# Service Bulletin

## SB 07-03 R4

Issued: 8/1/07  
Revised: 7/18/08

### BRS-600 Pick-up Collar Support Replacement

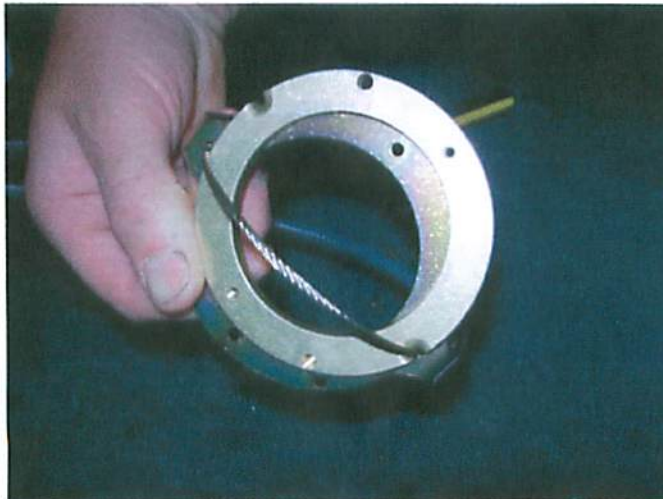
1. Acquire necessary tools, equipment and supplies.
  - a. Phillips screwdriver
  - b. Flathead screwdriver
  - c. 1/4" socket with torque driver
2. Insert that safety flag in activation handle.
3. Remove and discard nylon tension screws securing pick-up collar assembly to launch tube..

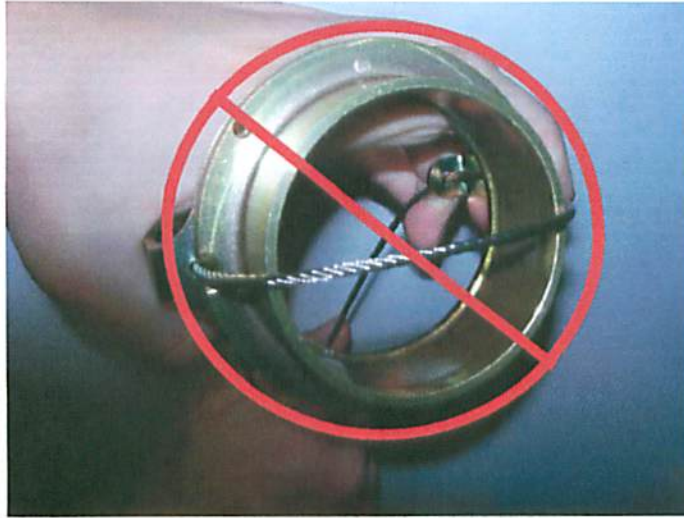
7. Discard existing pick-up collar support.
8. Inspect inner diameter of pick up collar for surface irregularities
  - a. Acquire necessary tools, equipment and supplies.

- b. Use half round file as required to remove bumps.
- c. Solvent clean with isopropyl alcohol
- d. Apply primer to affected areas

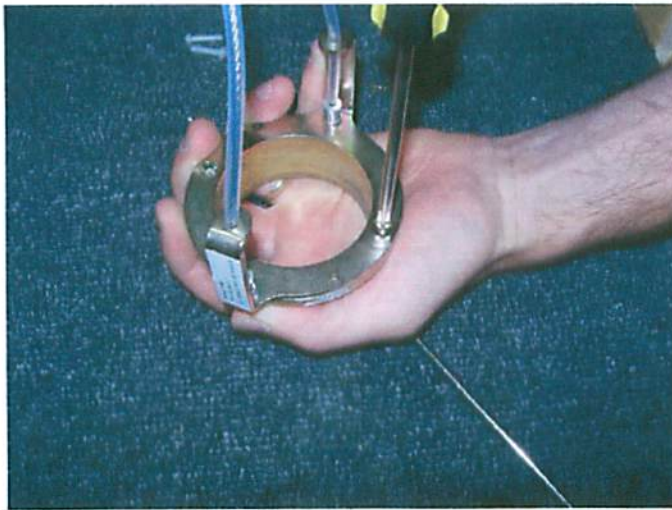
9. Position replacement pick-up collar support to upper side of pick-up collar.

**WARNING:** Position rocket lanyard around top outer diameter of pick-up collar support, NOT over top of rocket. Failure to comply will absolutely FAIL rocket deployment!

10. Position retaining groove of pick-up collar support to rocket lanyard. Pivot pick-up collar support until the rocket lanyard engages the opposite retaining groove.

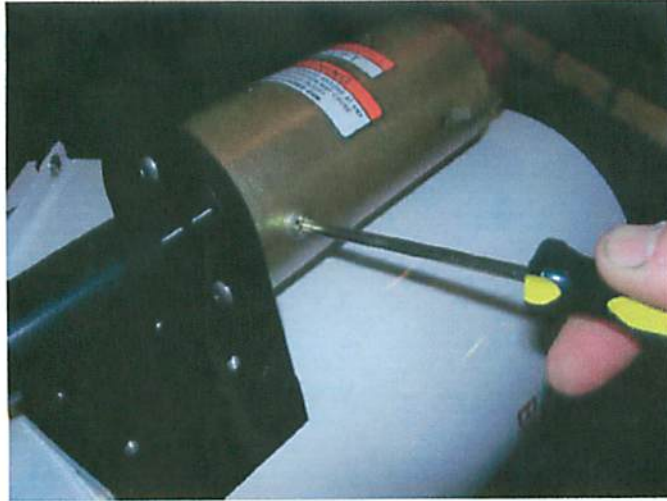
11. Apply Loc-tite (item 3) to screws removed previously from pick-up collar and attach new pick-up collar support to pick-up collar.

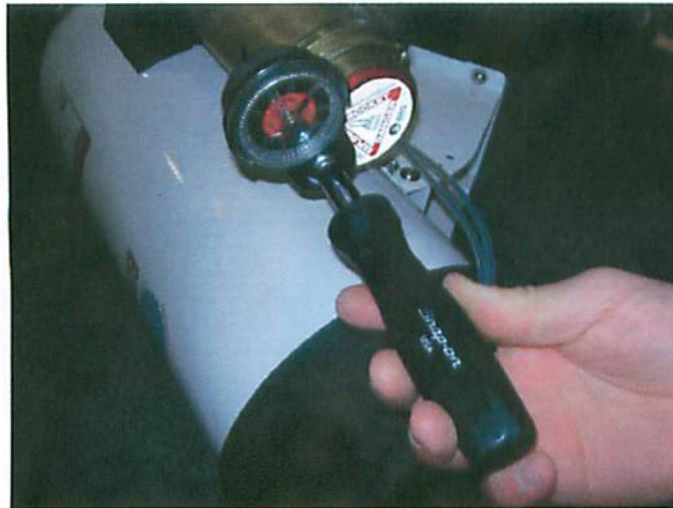
15. Verify pick-up collar assembly slides freely on rocket.

16. Verify anchor blocks are perpendicular to pick-up collar assembly. If pick-up collar is not fully seated against the anchor blocks, use pliers to gently adjust anchor blocks as required.
17. Verify rocket alignment is centered inside launch tube.
18. Apply threadlock to aluminum tension screw.

19. Install aluminum tension screws securing pick-up collar assembly to rocket launch tube. Tighten aluminum screws until snug (less than 5 inch-pounds or 0.57 Newton-meters).
